IMPORTANT SAFETY RECALL 20V-240

SN685

MODELS AFFECTED: TL80 & TL80/112 Telescopic Aerial Devices

SUBJECT: Incorrect Level Indicators and Decals

Figure 1. This bulletin applies if slope indicator and/or decal allows 5 degrees out of level.

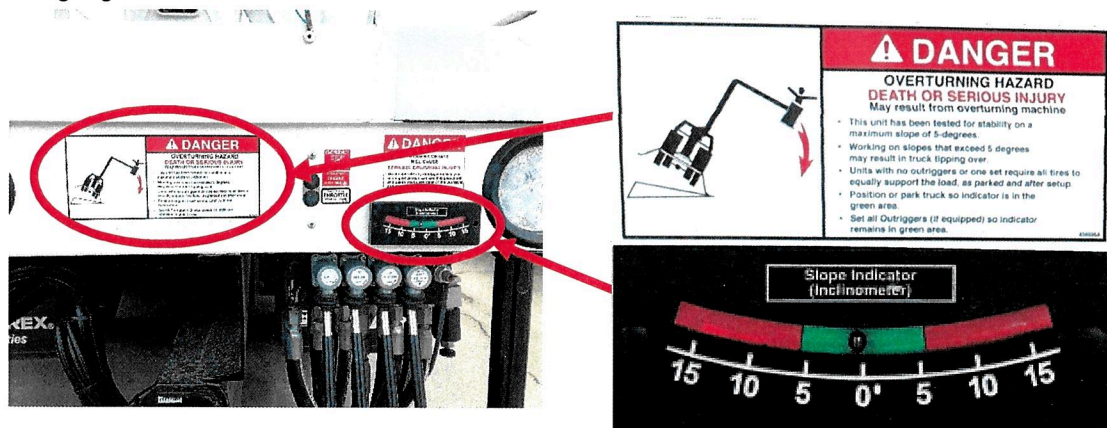
Terex TL80 & TL80/112 telescopic aerial devices, manufactured from March 2019 through March 2020, may be equipped with incorrect chassis slope indicators and overturning hazard decals. The unit must be level for use; however, the incorrect slope indicators and overturning hazard decals were installed which state that the unit can be used up to 5 degrees out of level. **If the unit is used with the chassis out of level it may result in an unstable condition which may cause the unit to tip increasing the risk of injury.**

3. If your unit has the slope indicators with the green band indicating use with the chassis up to 5 degrees out of level and/or a decal which allows use up to 5 degrees out of level, this bulletin applies. Contact Terex Utilities per the contact information in this bulletin to arrange repair and continue to use the machine following the continued use instructions in this bulletin.
4. If your unit has the bullseye slope indicator, which requires the level bubble to be centered, and decal 79584E, which states the unit must be level for operation, this bulletin does not apply and use can continue with the chassis level before operation of the boom.

Terex will provide replacement chassis level indicators and decals at no cost to the owner. Field Service kit Z1587, which will contain level indicators and decals, will be provided to the nearest Terex Utilities dealer or Field Service Technician for installation on your unit.
